## Design Review Board Study Session

**SUBJECT:** DR14-32 WARNER AND COOPER RETAIL DEVELOPMENT

DR14-32, Warner and Cooper Retail Development: site plan, landscape plan, grading and drainage, elevations, floor plans, lighting, colors and materials for approximately 2.12 acres located at the northwest corner of South Cooper Road and West Warner Road and zoned Community Commercial (CC) with a Planned Area Development (PAD) overlay ("The Islands Planned Area Development").

SHEET TITLE:  
PRELIMINARY ELEVATIONS

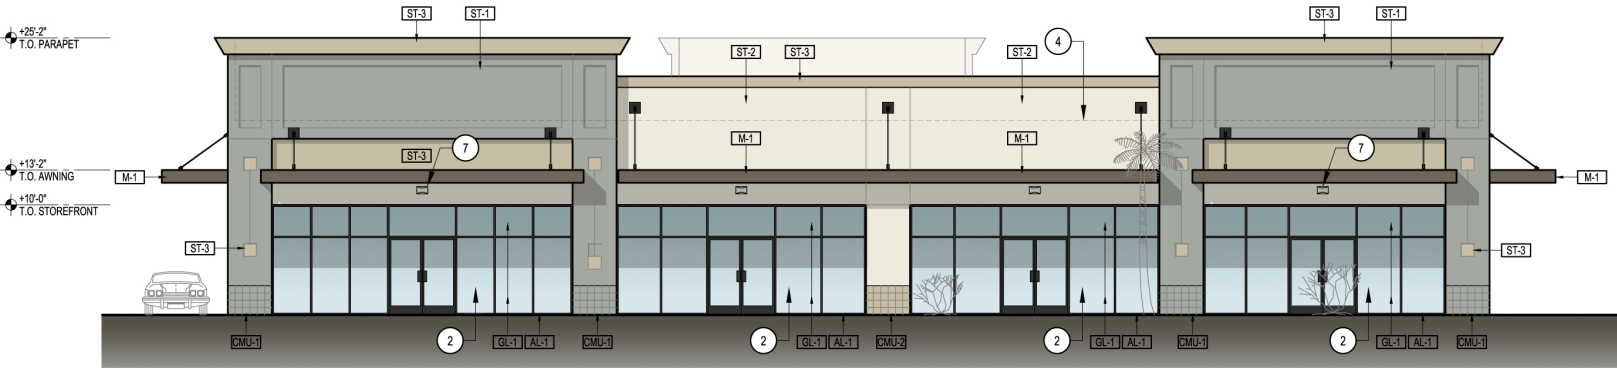
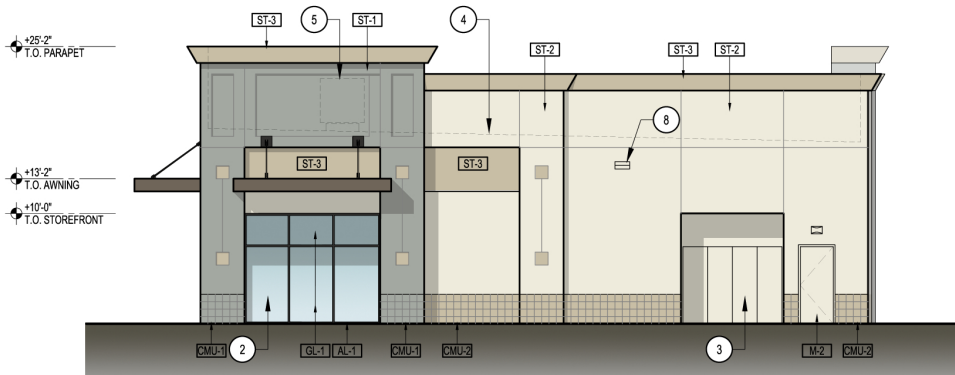
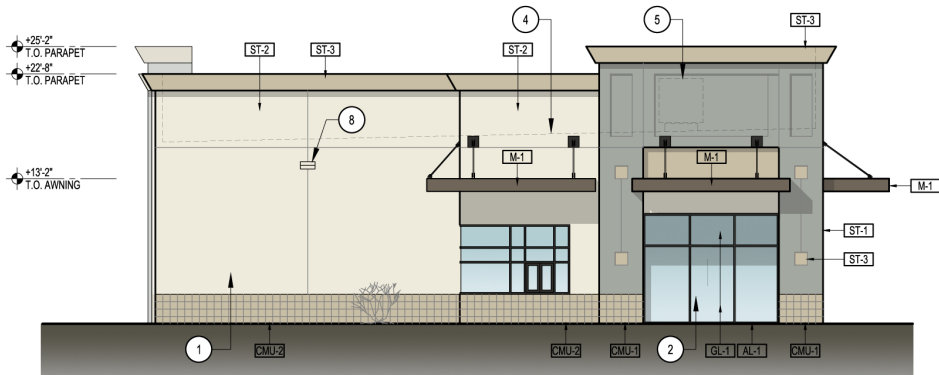
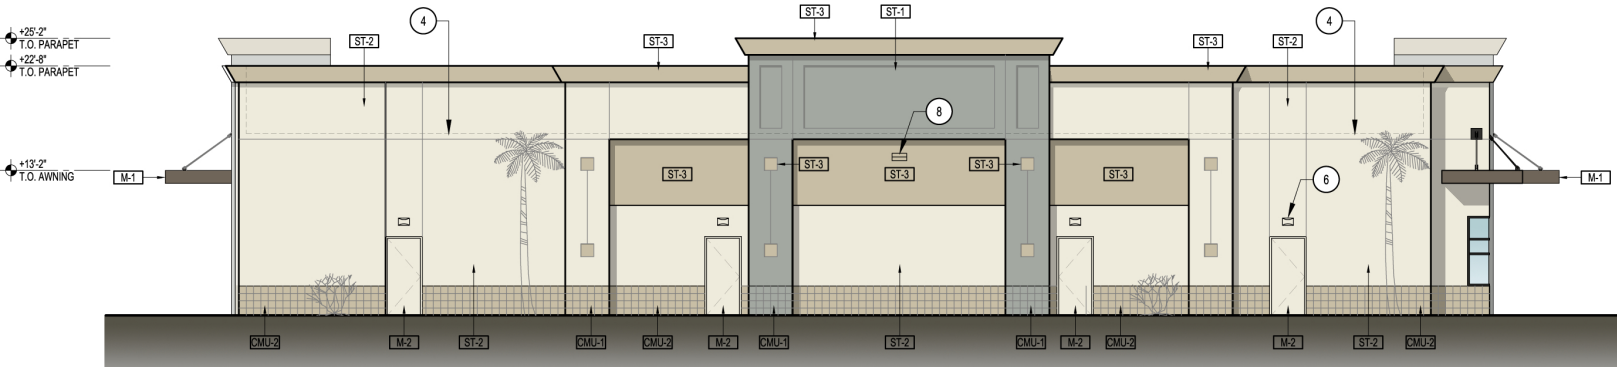
The exterior of the new proposed retail building is intended to complement the existing adjoining retail center buildings (See attached Exhibit 5. Elevations and Adjacent Development-Architecture). The proposed elevations and photo of existing development displays similar proportions, parapets, split-face painted wainscoting and E.I.F.S scoring architectural embellishments. The articulated walls, metal awnings and divided, clear glazed windows lend to an updated, contemporary design. The proposed building's color pallet draws from the same color pallet as the existing retail center immediately adjacent to the west. The minor difference is the proposed building's parapet color will be "Relaxed Khaki" rather than the green found on the adjacent, existing retail center. For the back of the parapets that can be seen from the public view, it is recommended the applicant paint the backs of those parapets.

1. Drive-through canopy width.
2. Painting back of parapets that can be viewed from public.

SHEET TITLE:  
PRELIMINARY FLOOR PLAN

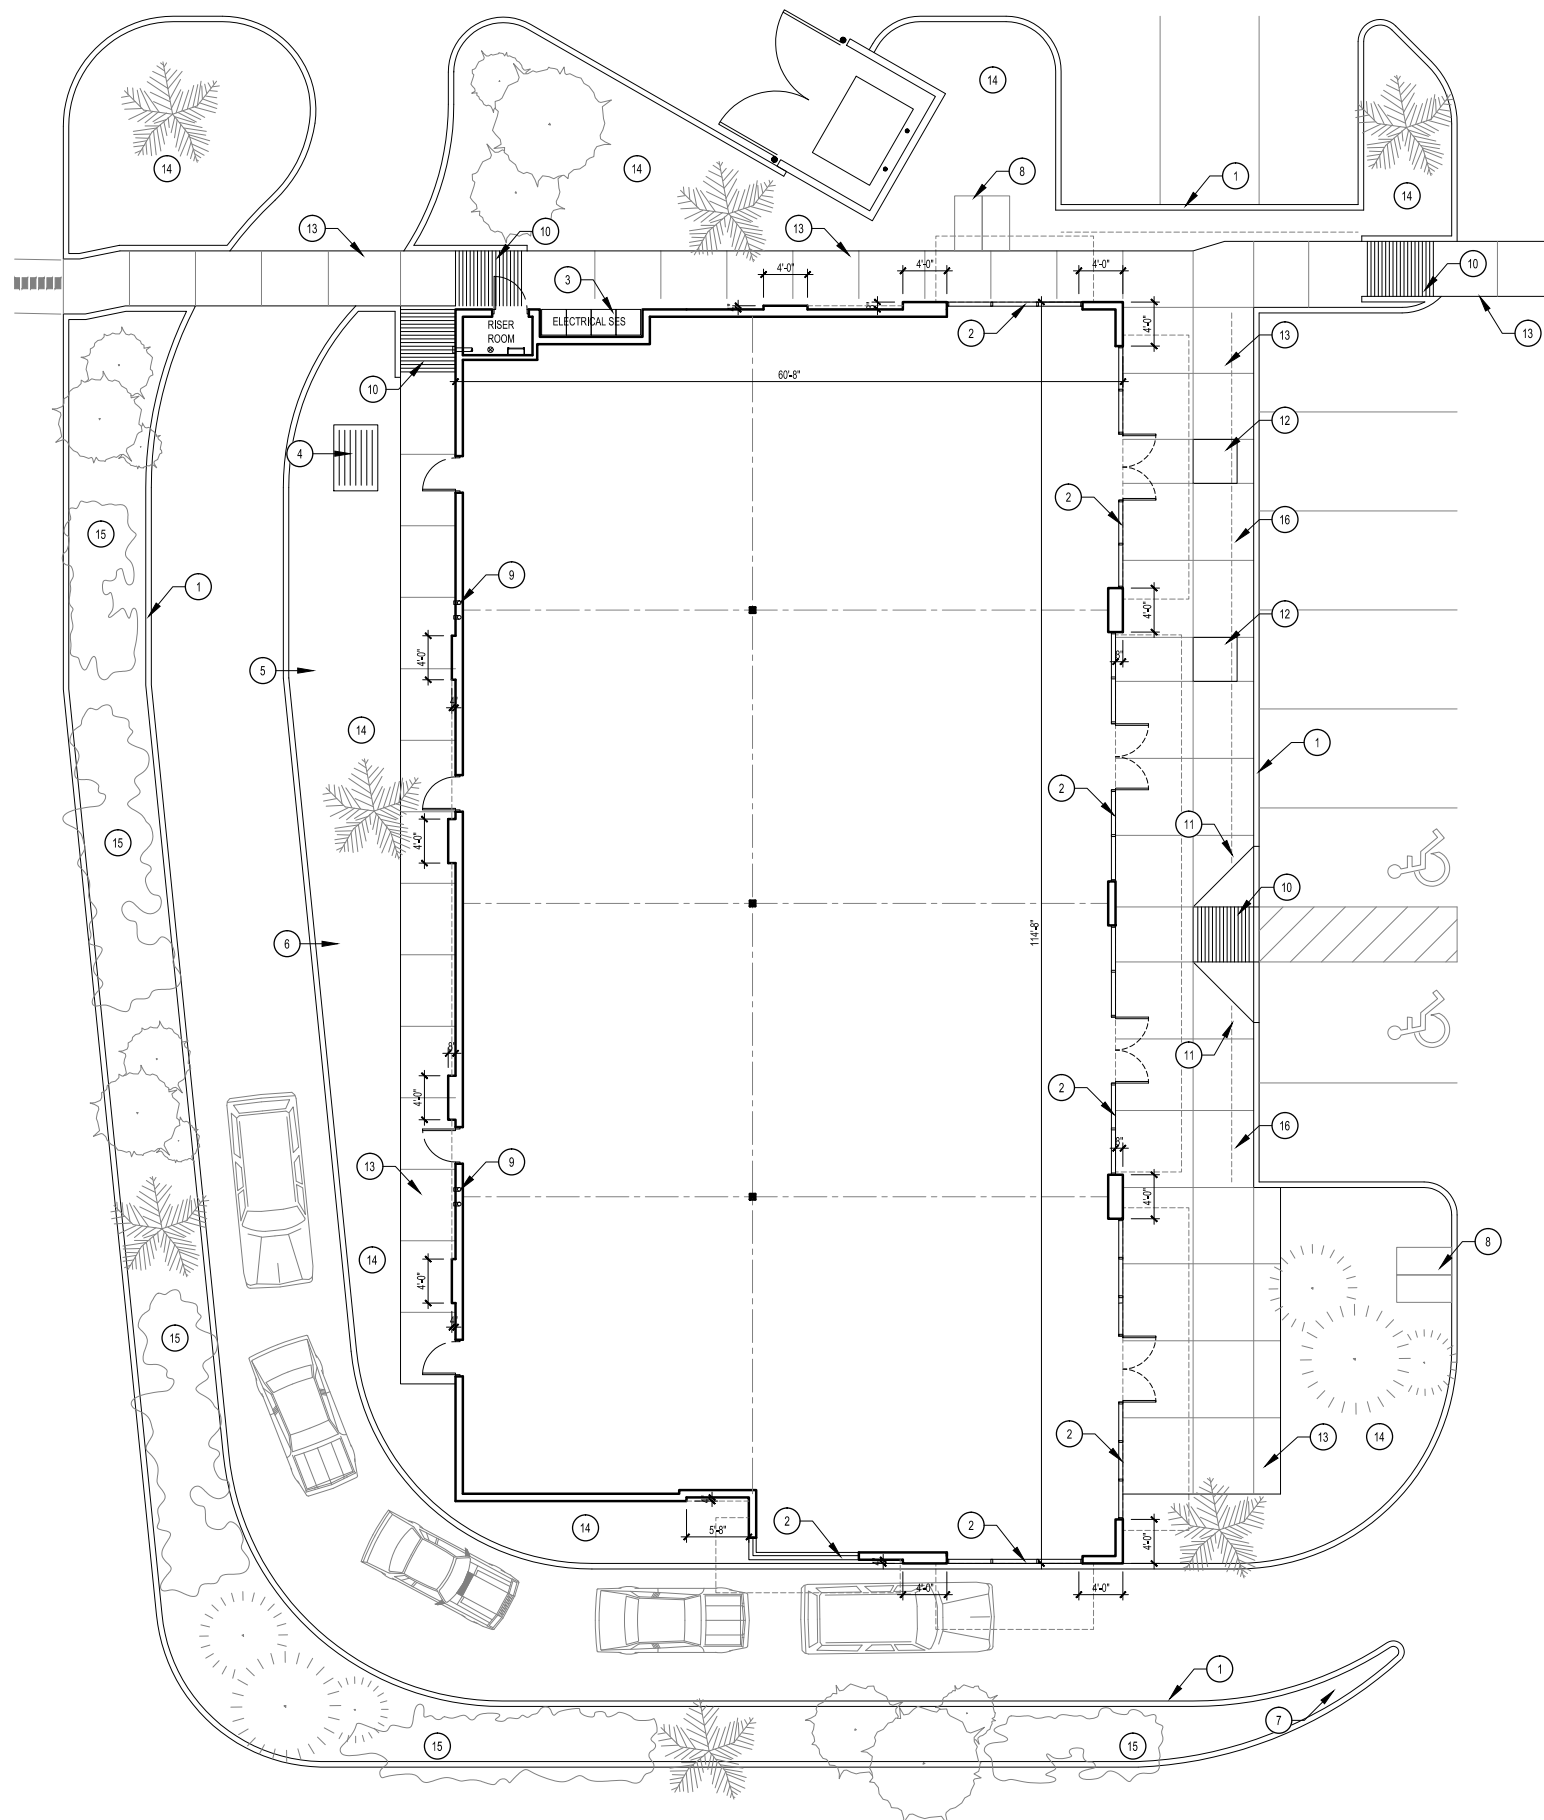
Please note the drive-through window is south facing with full solar exposure. It states in the "Commercial Design Guidelines", Section 2, Building Orientation, subsection f, "Provide weather and sun protection, such as overhangs, awning, canopies, etc. to mitigate climatic and solar conditions." Staff has consistently applied to projects design measures where all drive-through windows include an awning/canopy that covers the full width of the drive-through aisle. The drive-through aisle is 12'-0". The proposed canopy extends 2'-10 1/2" from the pick-up window which is approximately 9' feet less than the full width of the aisle. A second canopy, immediately adjacent and forward of the drive-through window extends 6'-1" from the wall. The applicant explained this would be a costly addition. It is recommended the drive through window's canopy be extended across the full width of the aisle (12').
